Geotechnical Review of the Quarry Backfilling, Kinley Estate, Lilydale

16 December 2020

Geotechnical Review of the Quarry Backfilling, Kinley Estate, Lilydale

Figure 5-1: % Hydro-consolidation and initial void ratio

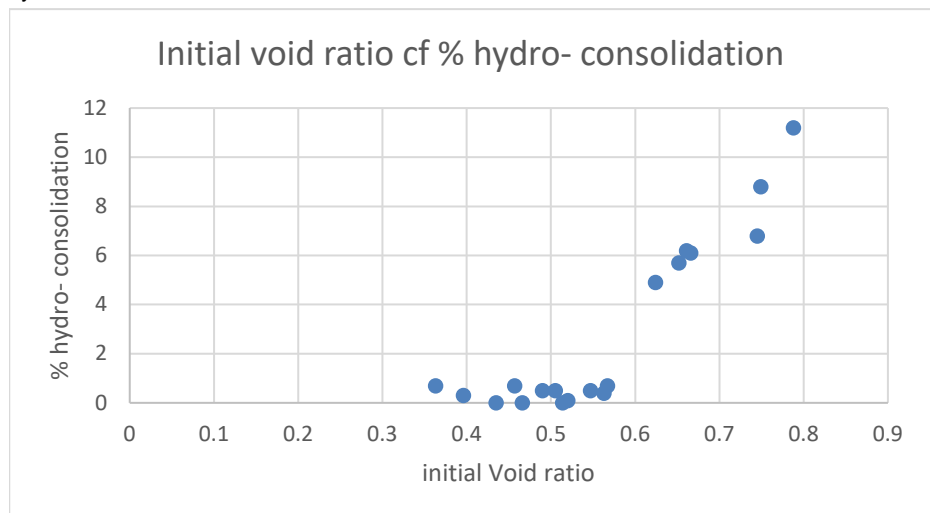
5	Upper Fill material	It is desirable to have low reactive material in the upper 2.5m or so of the fill material to reduce soil reactivity. It is recommended that low reactive suitable soils of not greater than 75mm in diameter in the upper 2.5m of fill be adopted.
5	Fill Suitability	We agree with all parties that organic matter, topsoil, pure silt, acid sulfate soils, contaminated soils and foreign matter are not suitable. The environmental suitability of the soils is not part of this assessment but could be provided if required. While the max particle size is limited to 300mm, limits on the % of oversized material and any gap grading must be undertaken to avoid voids occurring between boulders, not just a limit on size, and a visual assessment is recommended by Golder and we agree with the recommendation that the specification should contain a limit of coarse rock per m ³ .
5	Moisture Conditioning and Relative compaction	T & T argues that limits on the moisture placement is not required based on their testing. T & T propose to compact the fill materials, presumably at the field moisture content that is well dry of the OMC. We understand that this will make higher levels of relative compaction possible but considerable effort may be required by the contractor. The test results show that the level of compaction is the more important factor in reducing the hydro-consolidation than the moisture content, but the air void ratio is a combination of both of these factors. Using the results of the consolidation tests undertaken by T & T and notwithstanding some of the anomalies in the test data, the test results indicate a clear relationship between the initial void ratio (or relative compaction) with % collapse for a particular stress. If the initial void ratio is below 0.6, the % hydro-consolidation is below 1%.

As recommended by Golder, a target moisture limit should be specified for the specified DDR but can be fairly broad and it is acknowledged that the DDR is the more important factor.

Figure 5-2: Dry Density ratio compared with % hydro-consolidation

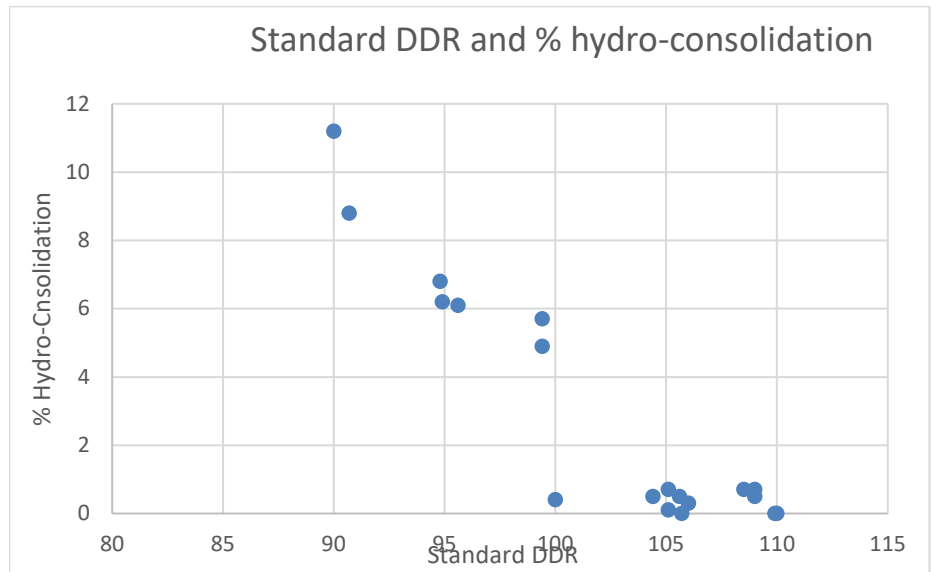
Expressed in another way, if the Standard DDR is equal to or greater than 101%, the collapse consolidation is less than 1% as the void ratio has been sufficient reduced. It is noted that a minimum average Standard DDR of 101% is specified for the filling of the quarry, but the minimum of 98% SDDR could undergo some greater hydro-consolidation.

Based on the T & T data, there is no direct relationship between moisture content alone dry of the OMC and the % collapse consolidation. A change in the density of the soil will have a bigger effect than a change in the moisture content. For example, a 10% change in the density will have a much bigger effect than a 10% change in the moisture content in reducing the void ratio. However, the literature indicates that % hydro-consolidation is expected to become greater as the moisture content becomes more dry of the OMC for the same DDR. (Waddell & Wong, 2005).

We agree with Golder comments about the need to avoid placing the material too dry of the OMC as it will create a higher air void ratio for the same DDR and the potential for greater future hydro-consolidation settlement. We also note that the placement of material too wet may mean that the DDR cannot be achieved and lead to saturation of the compacted clays. Porewater pressure dissipation is then occur as the fill becomes more loaded. However, it is noted that the higher compaction even if dry of the OMC can also reduce the air void ratio to an acceptable level.
